City of Corpus Christi

Meeting Agenda - Final

Planning Commission

Wednesday, October 15, 2025

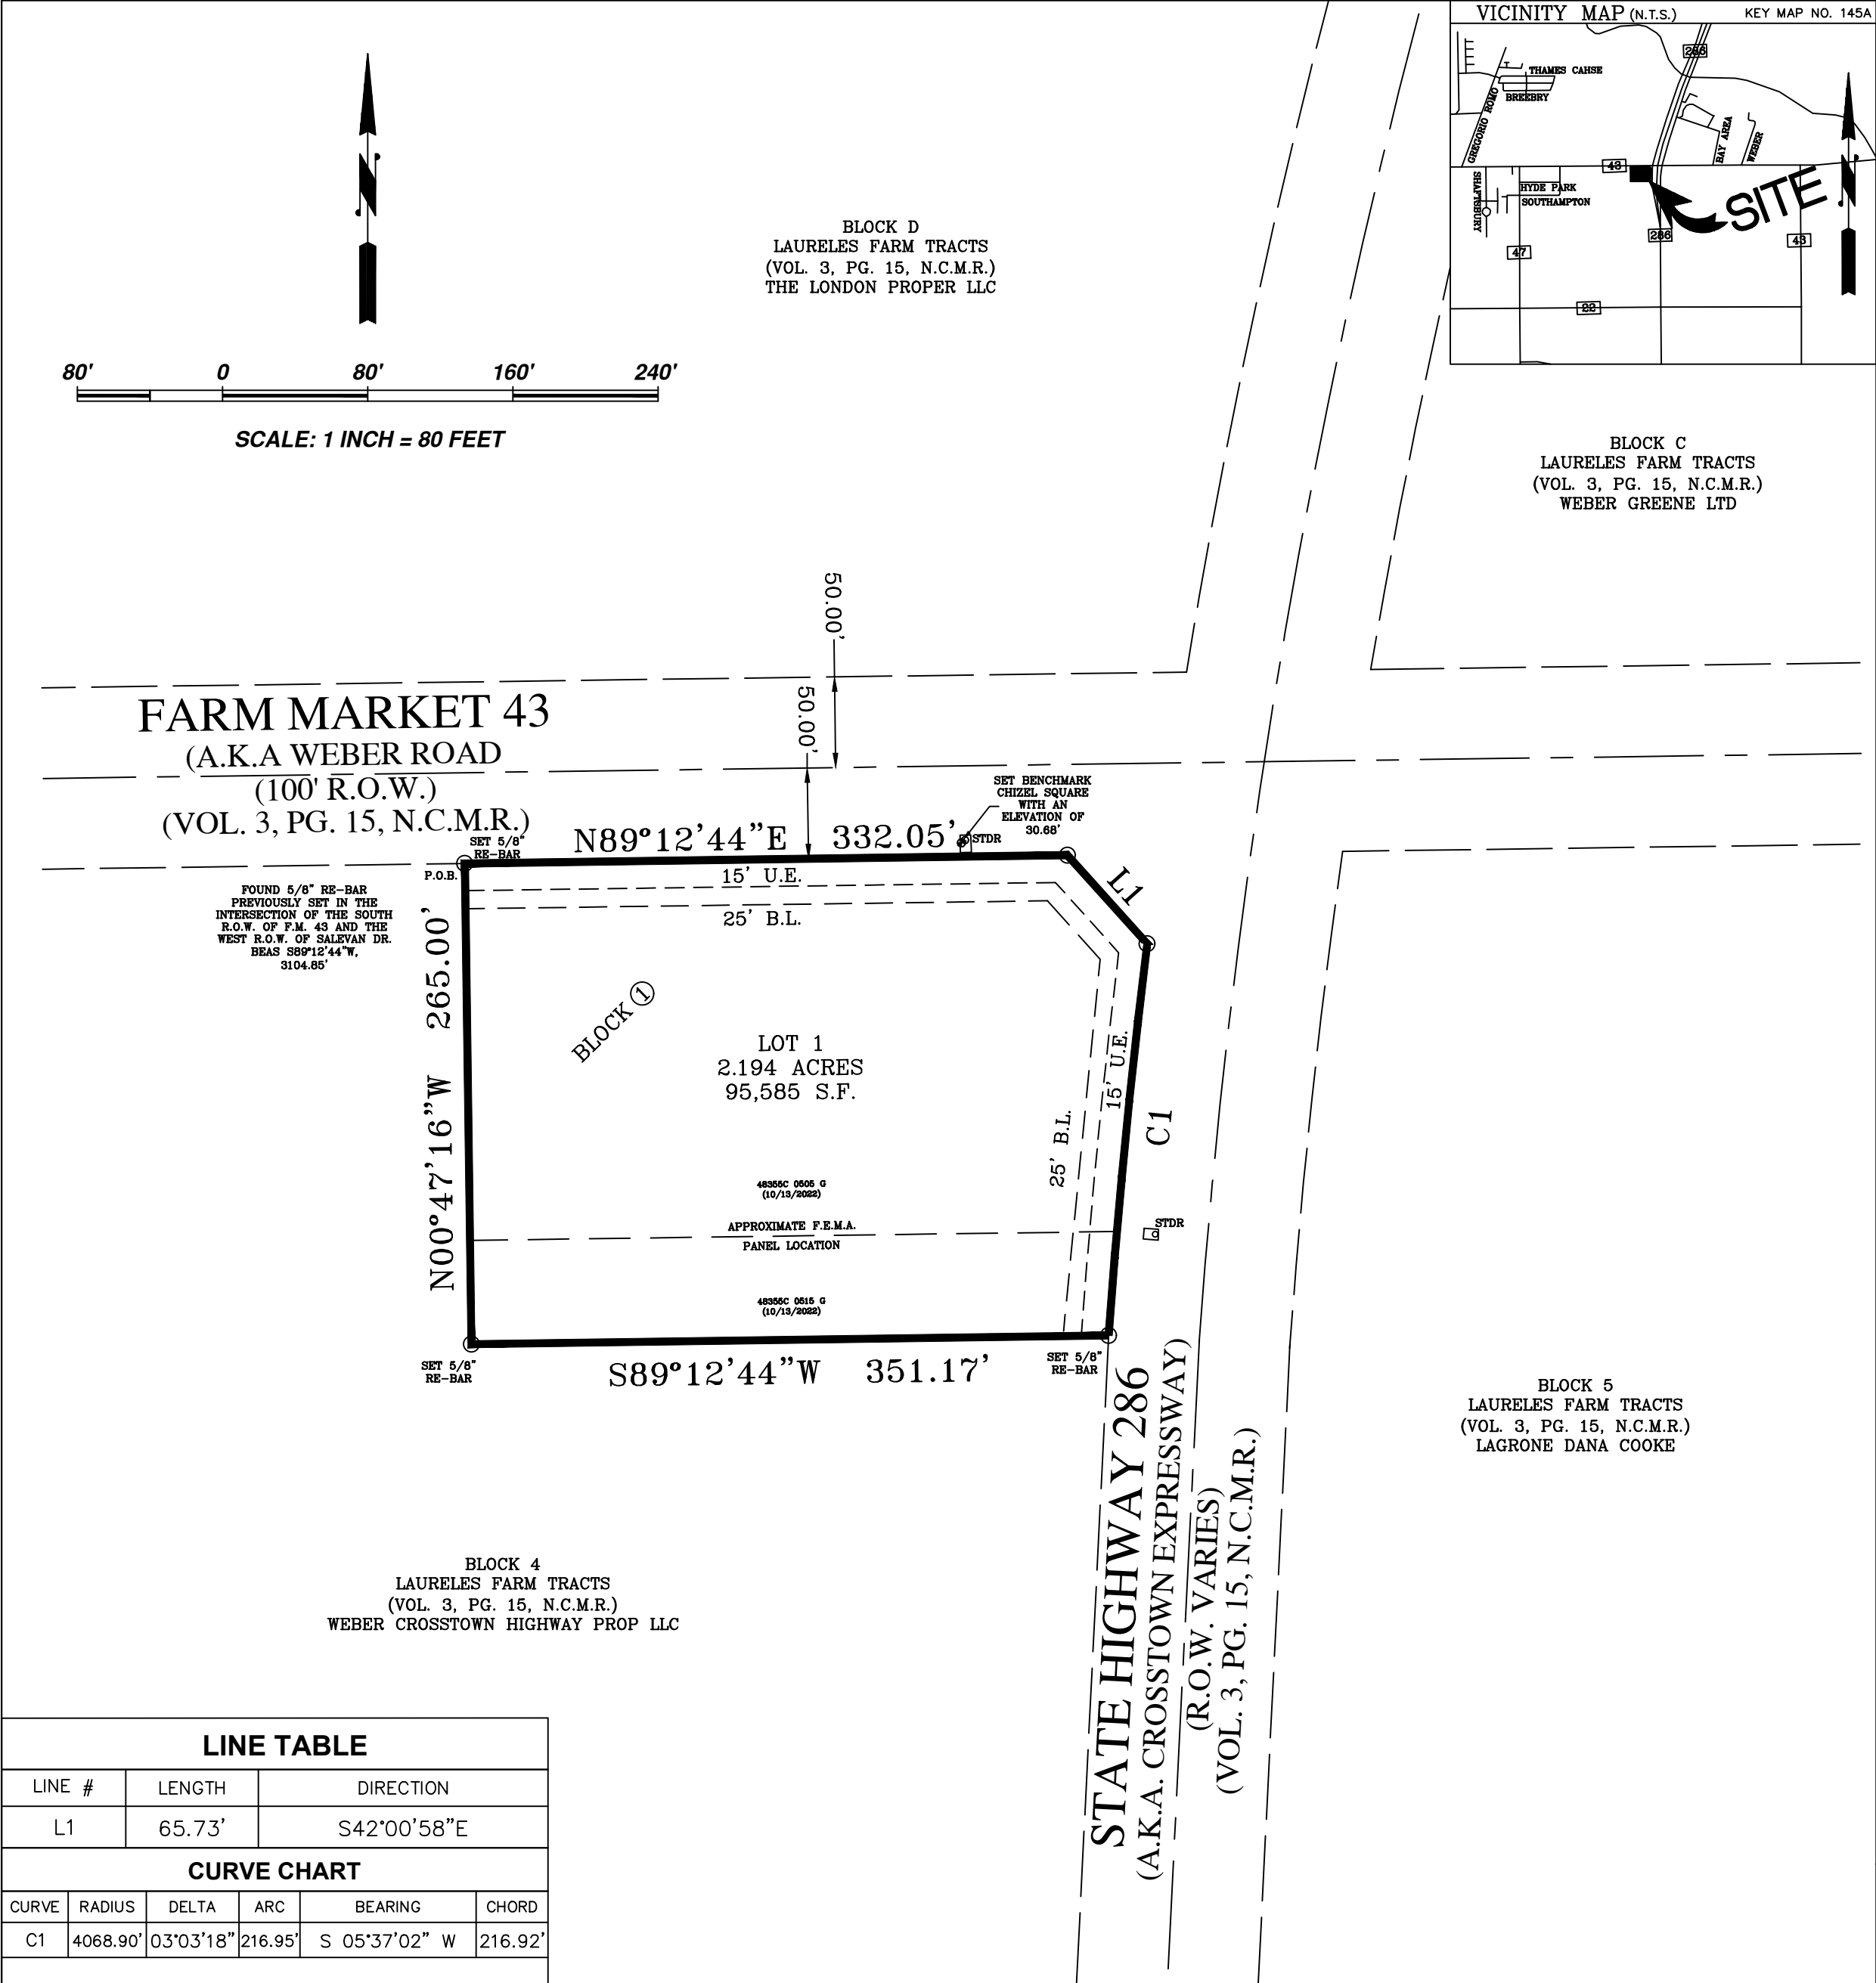
Comment ID	Author : Department	Status	Review Comments	Applicant Response Comments
6	Alex Harmon : DS	Open	<p>Update 7/23: CCW found that the existing (undersized) water line was abandoned as part of the TxDOT project meaning the lot is not served with any water making PIs required prior to plat approval.</p> <p>Improvements Required for Recordation, per UDC 8.1.4.</p> <p>A. Streets: No Sidewalks: Yes, at site development B. Water: At site development depending on fireflow testing Fire hydrants: At site development C. Wastewater: Yes, unless using septic system as it appears D. Stormwater: No</p>

Comment ID	Page Reference	Annotation Type	Author : Department	Status	Review Comments	Applicant Response Comments
3	P001	Callout	Mark Zans : LD	Open	Change public health engineer to Manuel Garcia
